Access Compliance Report

Public Rights-of-Way

(Curb Ramps)

Intersection ID: 28715	Main Street: EAGLE_CREEK_DR	Cross Street: DELAMERE_LN	Location: W
ADA ID: D9FD4990F30F	Ramp Type: Perp	Initial Pass/Fail: Fail	Overall Compliance: No
		Severity Score: 10

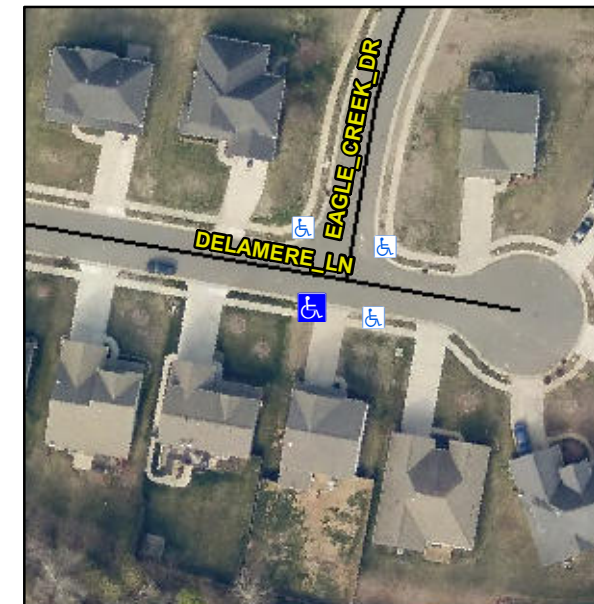
Not Found, R304.5.1, R304.5.3

Compliance	Description	Data	Compliance	Description	Data
N/A	Ramp Length (in)	46.5	Yes	Ramp Slope (%)	5.0
No	Ramp Width (in)	47.0	No	Ramp XSlope (%)	3.9
N/A	Flare Type LT	N/A	N/A	Flare Type RT	N/A
N/A	Flare Slope LT (%)	N/A	N/A	Flare Slope RT (%)	N/A
N/A	Flare Traversable LT?	N/A	N/A	Flare Traversable RT?	N/A
N/A	Landing Length (in)	N/A	N/A	DWS Provided?	N/A
N/A	Landing Width (in)	N/A	N/A	DWS Contrast?	N/A
N/A	Landing Slope (%)	N/A	N/A	DWS Length (in)	N/A
N/A	Landing X Slope (%)	N/A	N/A	DWS Full Width?	N/A
N/A	Landing Curb? (Y/N)	N/A	N/A	DWS Offset (in)	N/A
N/A	Shared Landing?	N/A			
N/A	Gutter Ponding?	N/A	N/A	Gutter Slope (%)	N/A
N/A	Gutter Lip Ht (in)	N/A	N/A	Gutter X Slope (%)	N/A
N/A	Painted X Walk1?	No	N/A	Painted X Walk2?	N/A
	X Walk 1 Direction	To N		X Walk 2 Direction	N/A
N/A	X Walk 1 Width (in)	N/A	N/A	X Walk 2 Width (in)	N/A
	X Walk 1 Slope (%)	3.0		X Walk 2 Slope (%)	N/A
	X Walk 1 X Slope (%)	3.4		X Walk 2 X Slope (%)	N/A

Remove & Replace Entire Ramp.
